# ONE SYDNEY HARBOUR

## BARANGAROO

R5 SUPPLEMENTARY DESIGN STATEMENT FOR S4.55 MODIFICATION - RESPONSE TO SUBMISSION  
March 2021

Proposed Ground Floor Plan

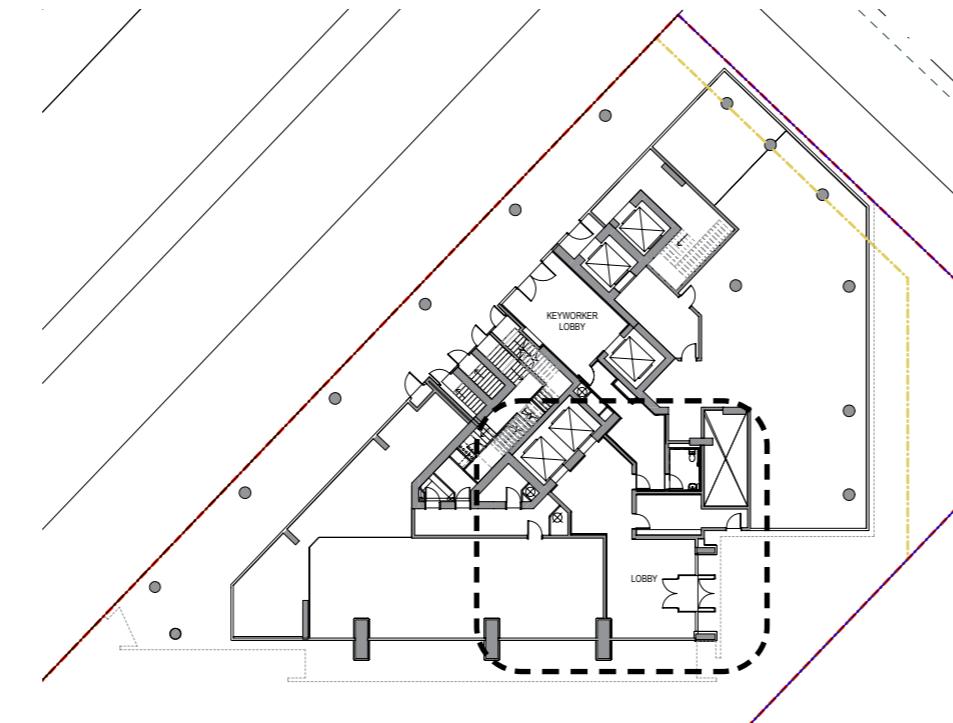
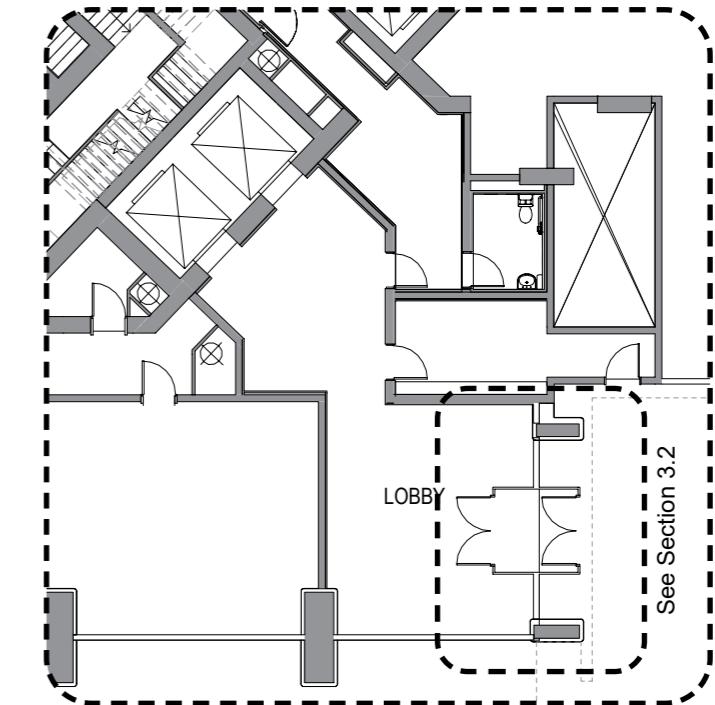
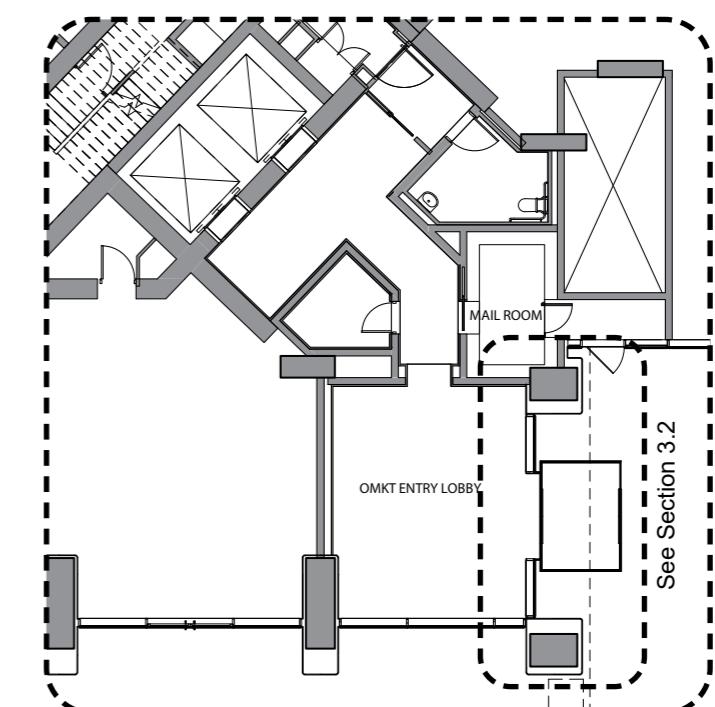
To maintain consistency across the precinct towers, the R5 Ground Floor Plan has been revisited and refined to align with the design principles including:

1. Re-configuring the On-Market residential lobby to define a hierarchy of space between the lift lobby and the waiting area and improve the sequence of entry
2. Geometry and proportion of the spaces was improved increasing user amenity
3. Consistency of scale and volume of the lobby with R4A and R4B
4. Relocation of the Retail lift core to increase flexibility in the division of retail tenancies
5. Redevelopment of the column cladding to the park facade to line with the revised facade alignment of the tower above.

Proposed Entry Vestibule

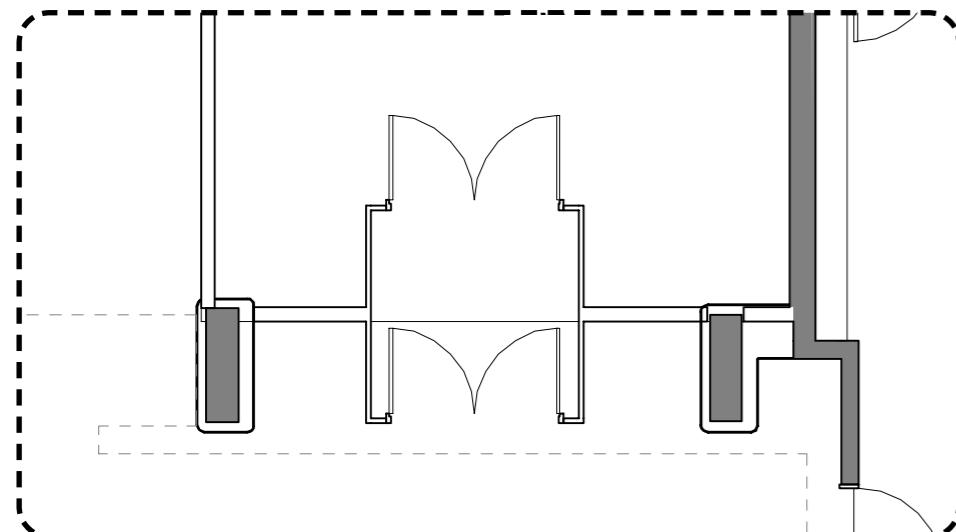
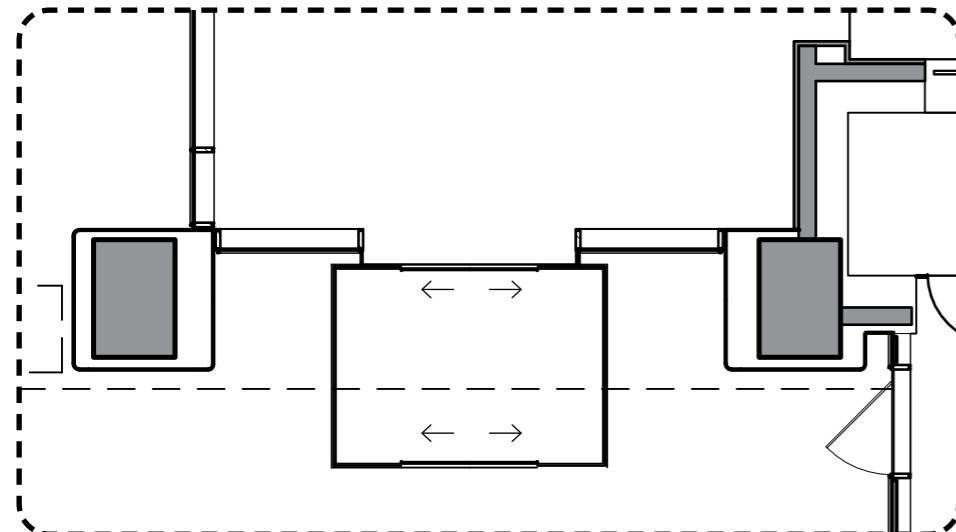
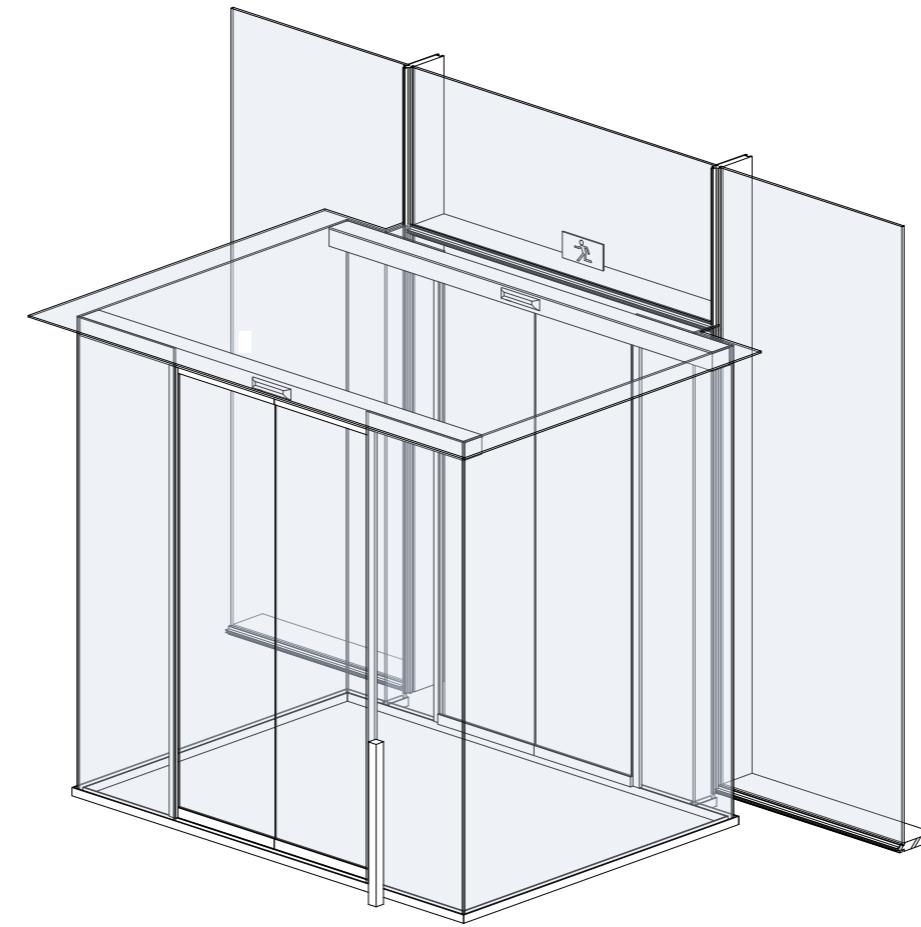
A pedestrian comfort and safety study was undertaken during the initial stages of the design development.

This study indicated that the wind conditions precluded the use of swing doors in the zone immediately outside the residential entrance due to the occurrence of periodic high wind events within the precinct.

As a consequence, the configuration of the entrance vestibule was investigated and the attached images describe the revised design proposal which has simplified and improved the architectural response of this facade component.

Automated sliding doors have been integrated in lieu of swing doors, improving safety as well as creating a seamless transition from outside to the on market lobby interior.

This amendment has resulted in a minor adjustment to the dimensions of the lobby vestibule. This amendment has been integrated into the modulation, proportion and geometry of the facade to provide a design response that meets the design standards of the precinct architecture.

Proposed Signage Zone - On Market Lobby

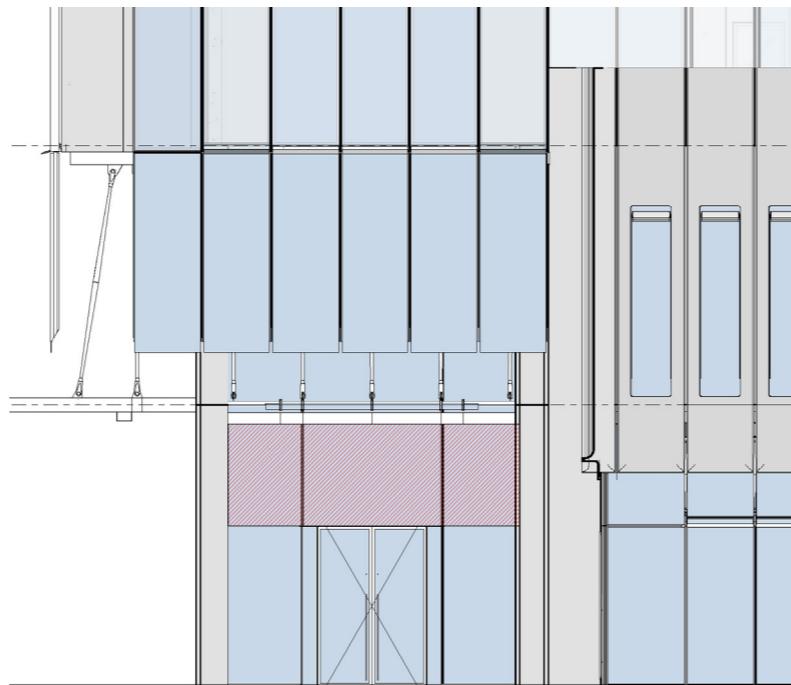
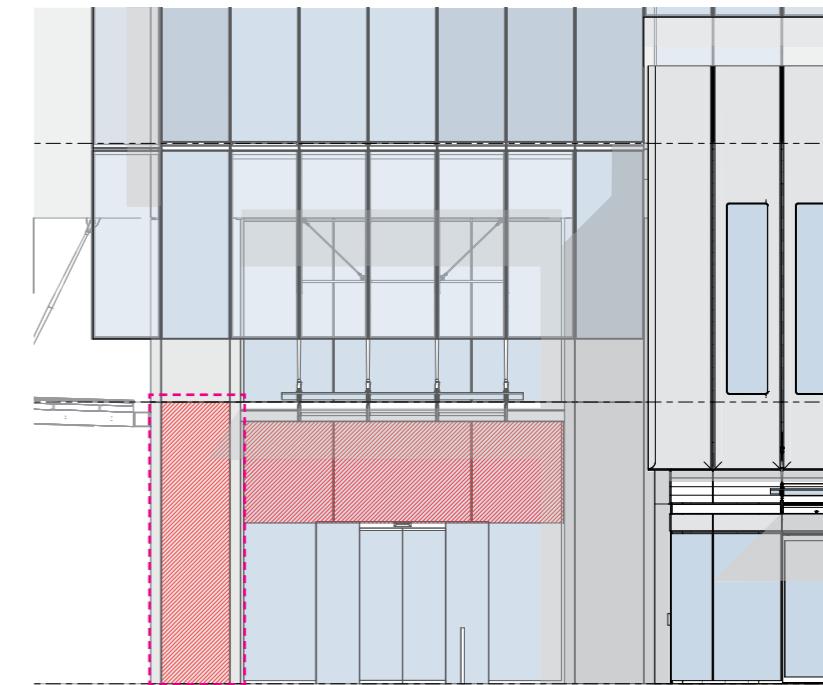
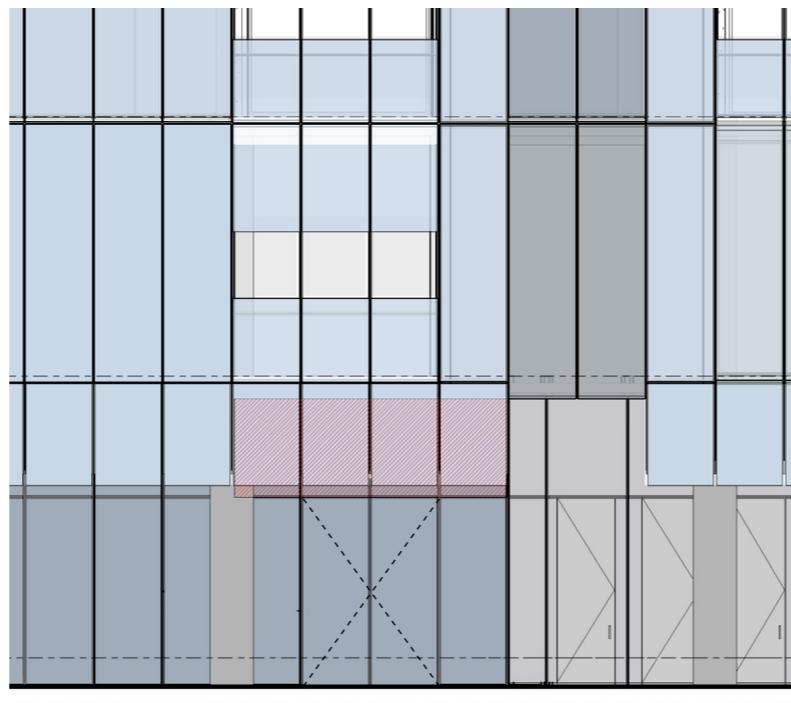
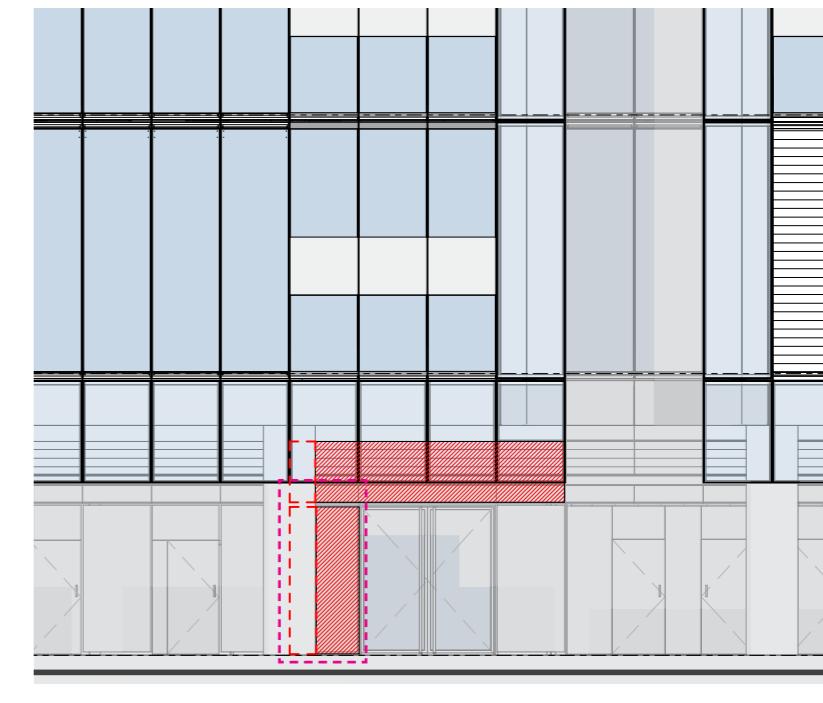
Following developments on R4A and R4B towers and a comprehensive consideration of the signage within the precinct, an amendment is proposed to R5 building signage zones. An additional signage zone is proposed to be located vertically against an opaque surface adjoining both the On Market and Key Worker Housing lobby entrances.

The inclusion of two signage zones for each lobby provides flexibility in the choice of the location, guaranteeing a final sign consistent with the remaining towers. However, in accordance with the Concept Plan, only one sign per elevation (per lobby) will be provided.

The proposed final sign will be individual lettering on the opaque cladding in the signage zone.

Proposed Awning scheme

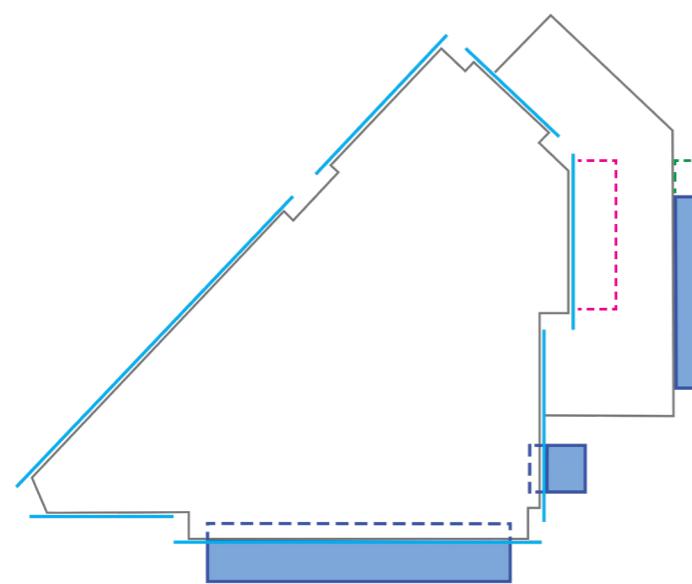
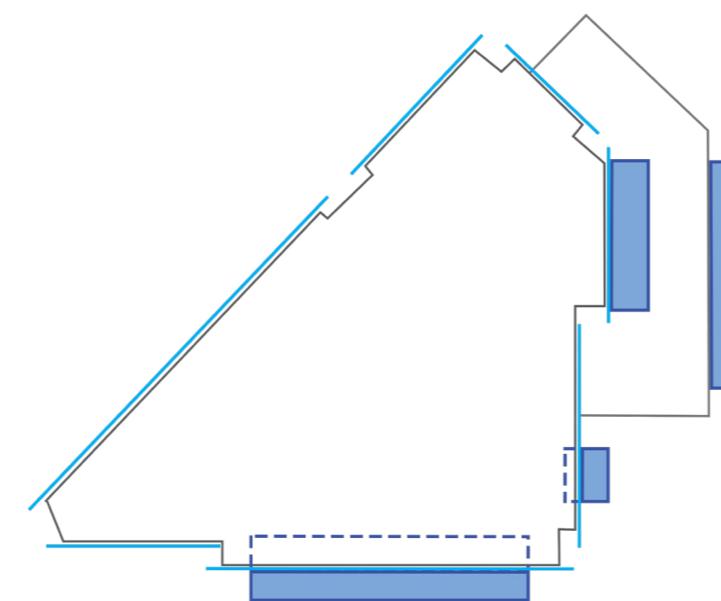
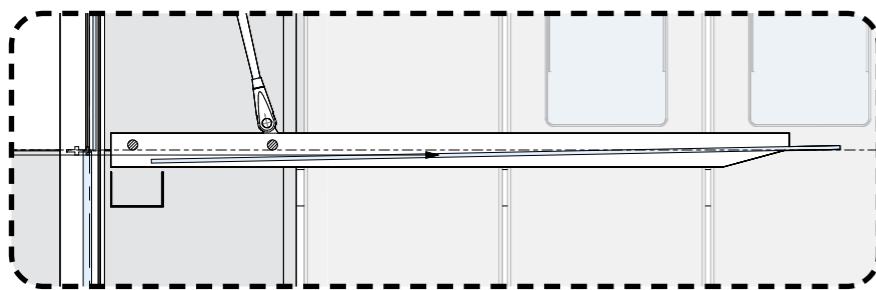
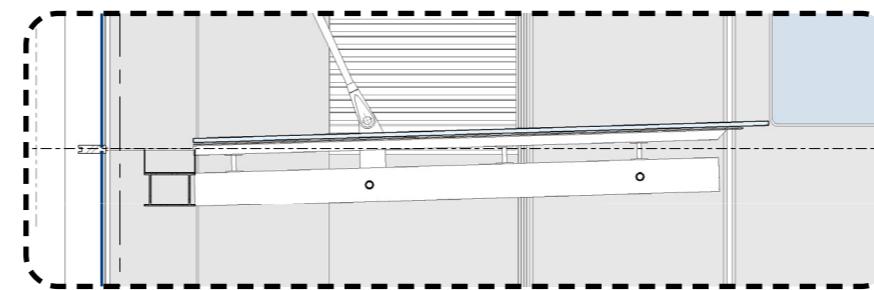
All awning geometry was reviewed to be consistent with R4A and R4B as per the following schematic sections.

The retail awning on the south-west podium facade is proposed to be extended towards Watermans Quay, allowing for an increased awning covered area and locating the canopy symmetrically on the retail facade.

A new awning is proposed on the podium terrace at P02. This is envisaged to maintain consistency with the solution adopted on R4B, where the awning creates a buffer area between the covered amenities and the exterior terrace, additionally working to protect the users from adverse weather (both wind and driven rain).

Elevation 1: Proposed Scheme

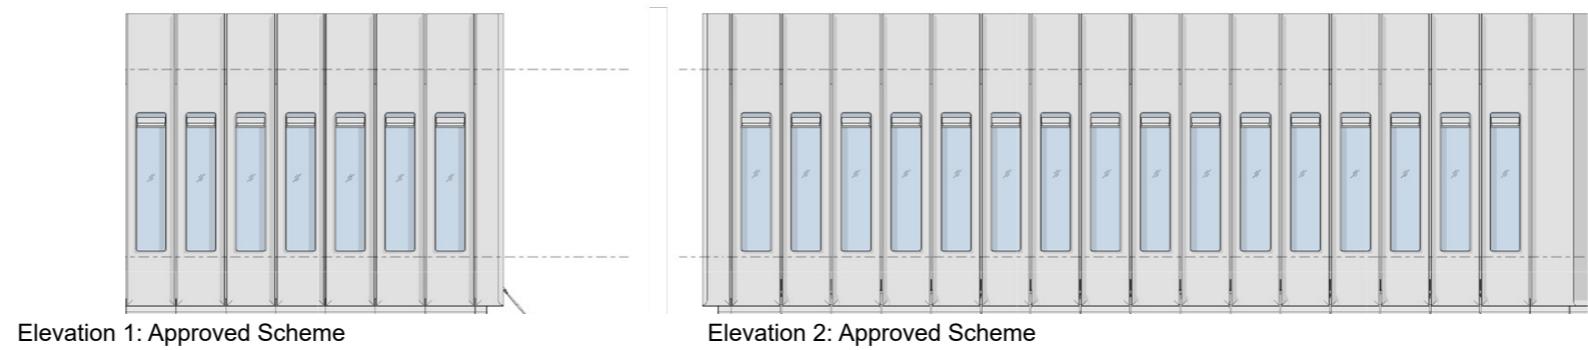
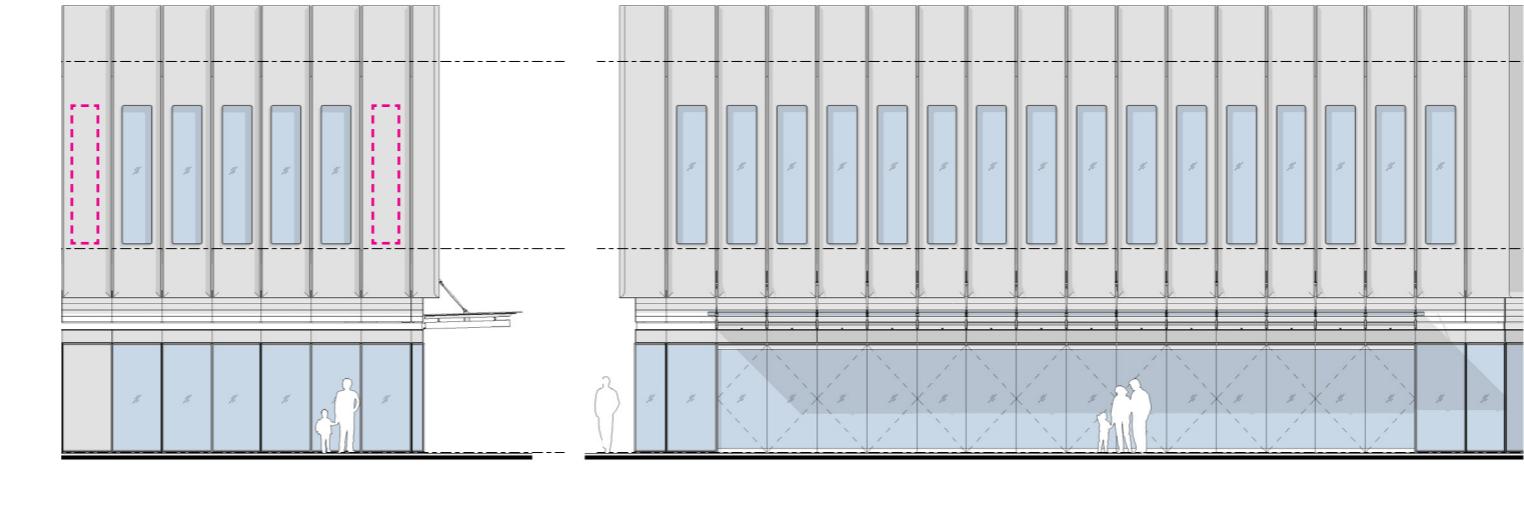
The window layout on the four podium facades were re-studied with the aim to have more robust edges, and a symmetrically balanced window arrangement.

The proposed design includes changes to three facades as described in the following diagrams.

External roller blinds have been removed from the facade and internal ones are proposed instead. This change is consistent with the approved R4B building, and is in response to the precincts environmental conditions.

### 3.6 Amended Podium Amenities and Terrace

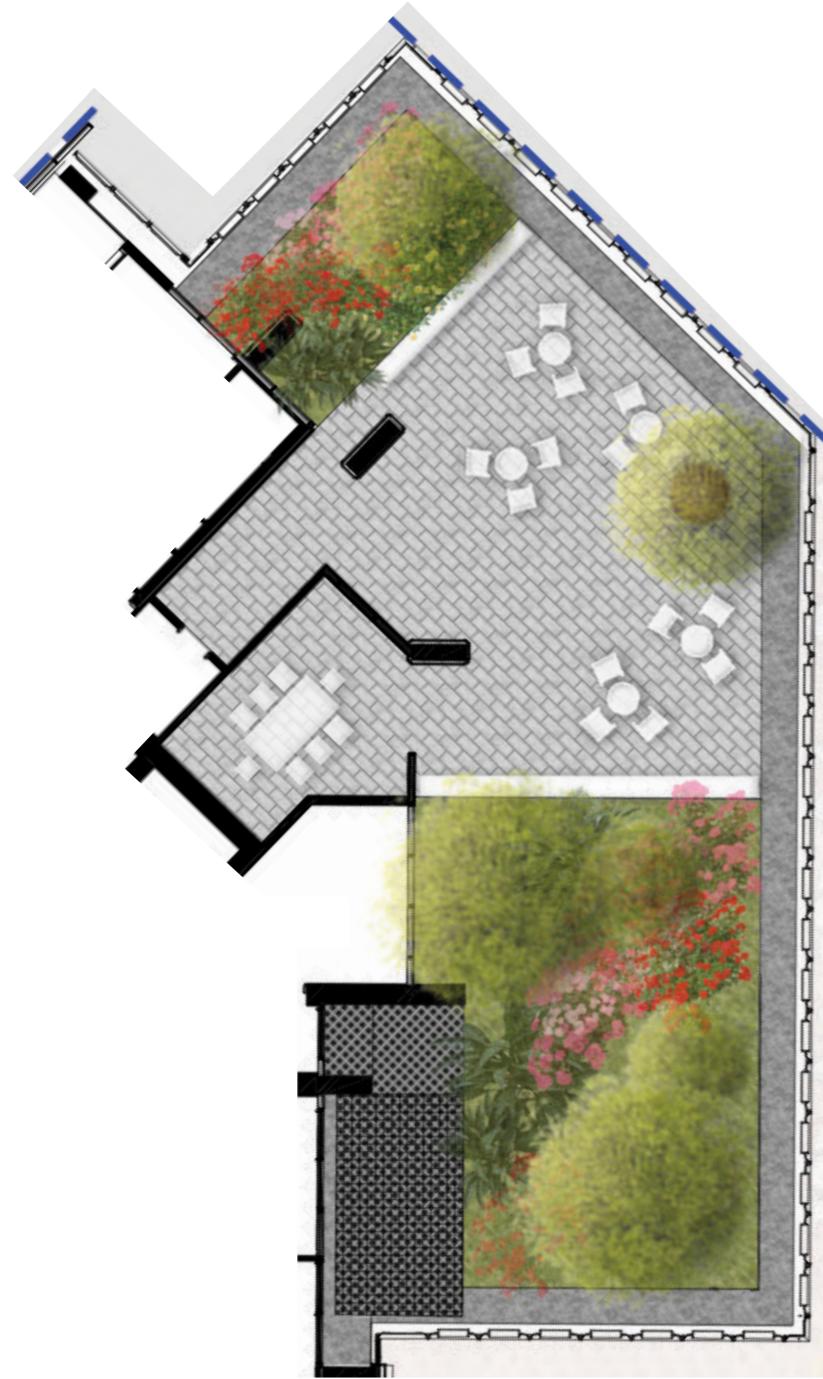
In response to the additional GFA made possible under the Barangaroo Concept Plan Modification 10, the P02 Key Worker Amenities area has been revised under this modification to provide a superior outcome for the Key Worker residents.

The proposed amenities include a fully enclosable space, which will allow for the area to be used year-round, regardless of the weather. Bathroom amenities have now also been included.

The exterior open space was also reviewed, with the introduction of the awning (see section 3.4), and with an amended landscaped proposal as per following sketch.
